**SOITEC SOLAR DEVELOPMENT  
PROGRAM ENVIRONMENTAL IMPACT REPORT**

**3800 12-010 (GPA); Tierra Del Sol, 3300 12-010 (MUP), 3600 12-005 (REZ),  
3921 77-046-01 (AP); Rugged Solar, 3300 12-007 (MUP);  
ENVIRONMENTAL LOG NO.: 3910 120005 (ER)**

**PUBLIC REVIEW COMMENT SHEET**

Figure 1. Well RM-1 Water Level Data

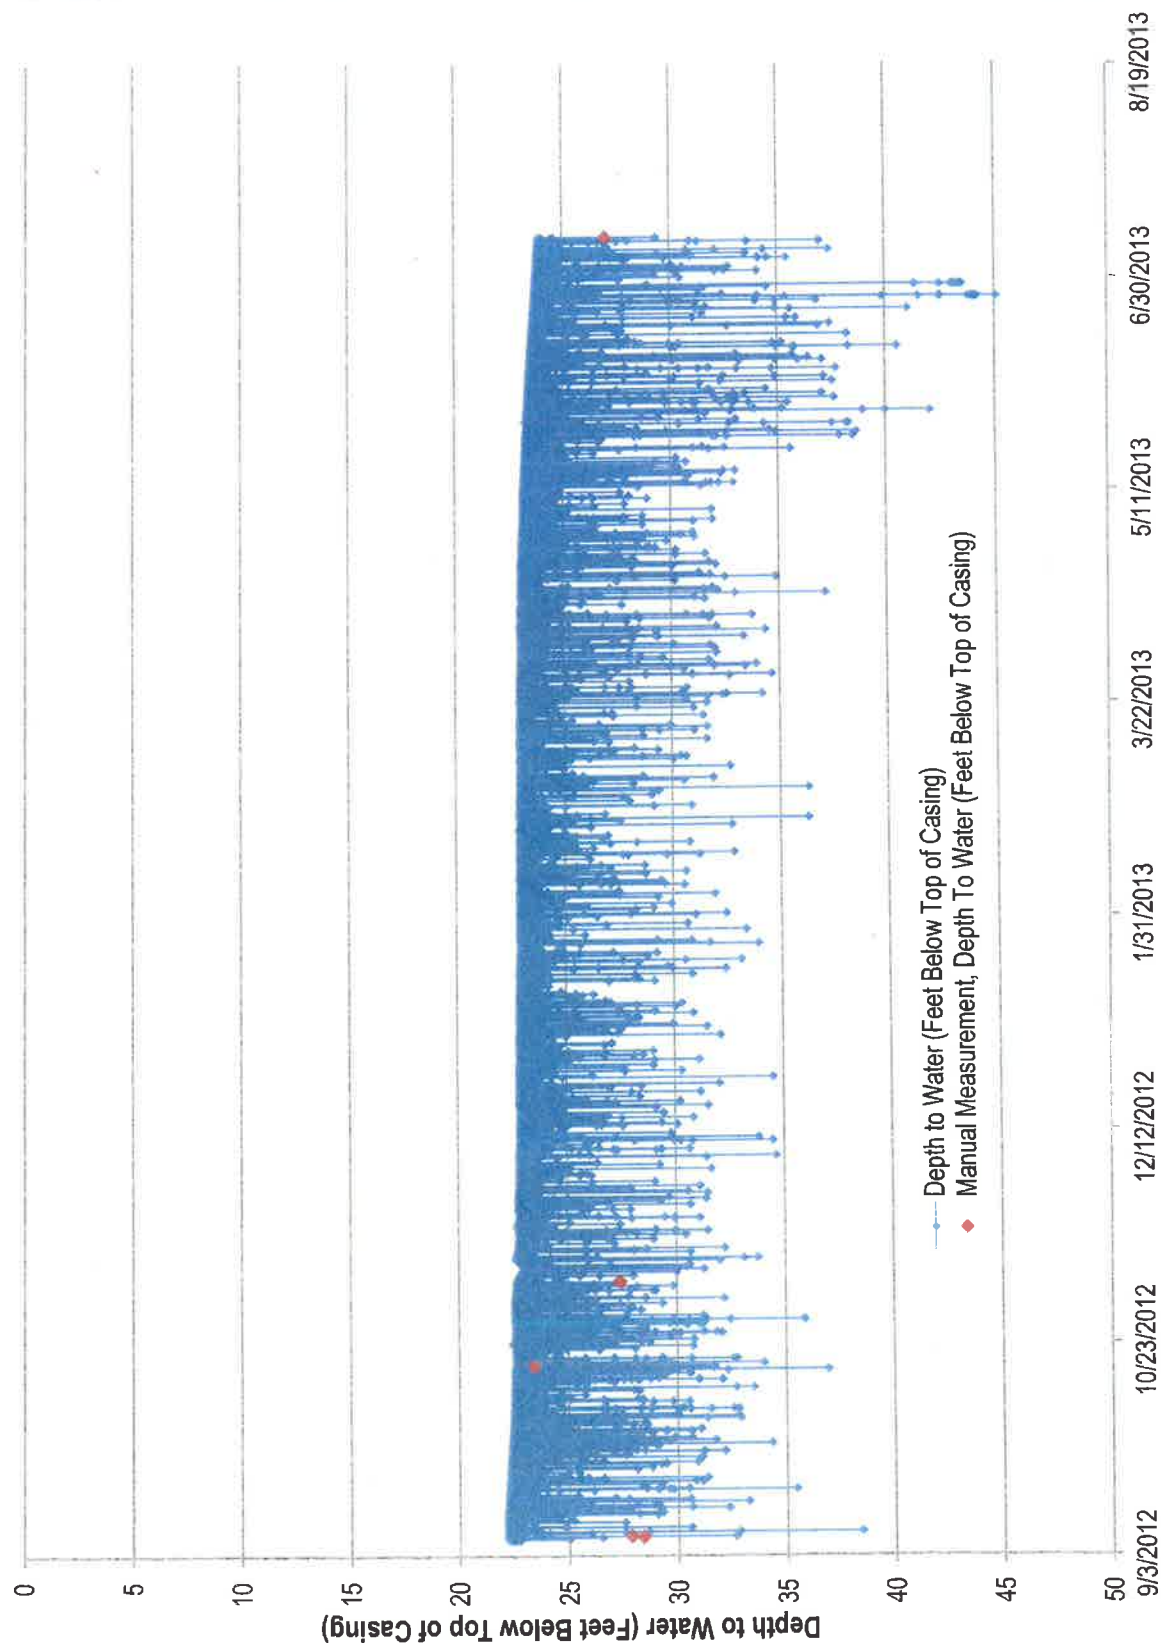
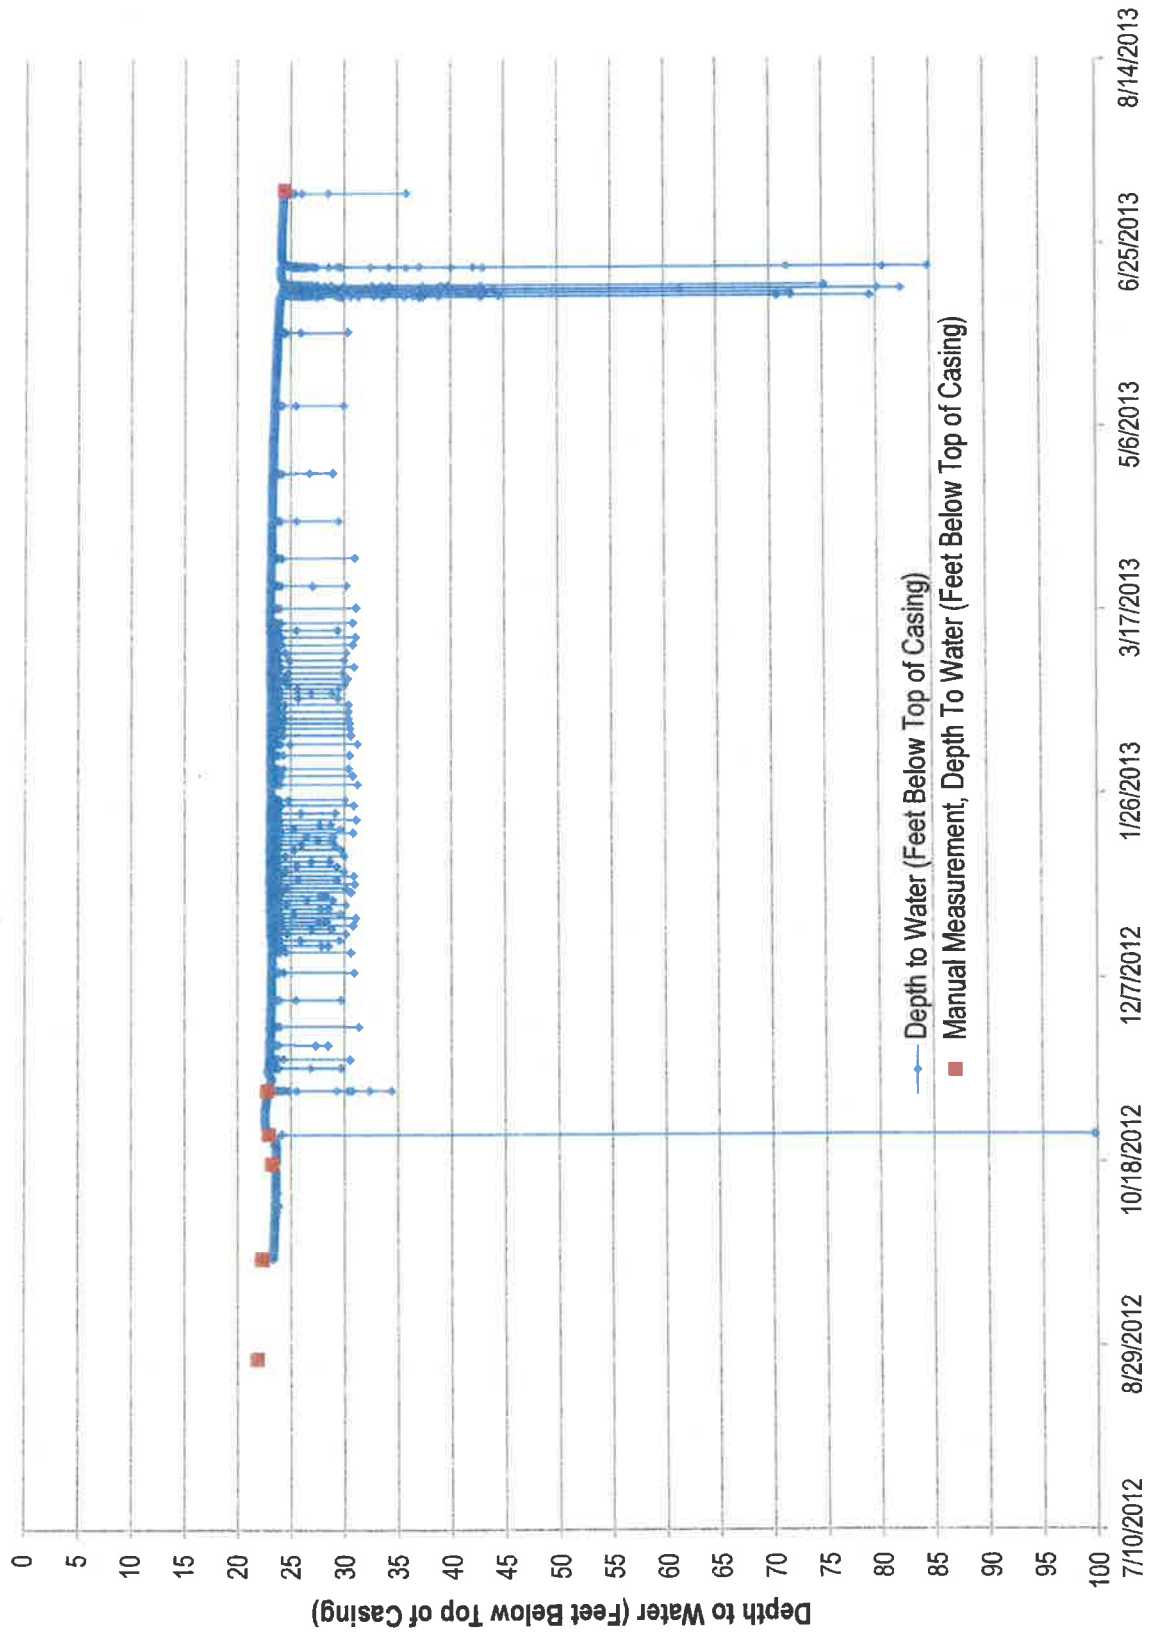
In the E I R ( 3.1.5 ), copy included with well water level data from Dudec, it looks like they did the 72 hour draw down test in June. RM-2, my well in the pasture, dropped from about 25 feet below the top of the casing to 85 feet. Or a drop of approximately 60 feet. RM-1 is the well that supplies my house. It dropped from approximately 24 feet from the top of the casing to 45 feet below. A drop of 21 feet. The test well B was to be the 72 hour test according to the Dudec people. We have no grass in our yard to water and few plants, due to the water shortage in the area. The E I R written by Dudec for the Soitec solar project is so misleading it is on the verge of being criminal. Dudec did a ground water survey for a project in Poway stating that the ground water to be used by the project would in no way have an effect on the surrounding users. On the strength of that, the project was approved. A ground water survey done at the same time by Victor M. Ponce stated that, if the project went forward, the local ground water would be severely affected. It was ignored, probably due to lobbying, although I can't prove it. Within 60 days the water in the surrounding wells dropped drastically. I am including the ground water study done by Mr. Ponce for the Boulevard and surrounding communities.
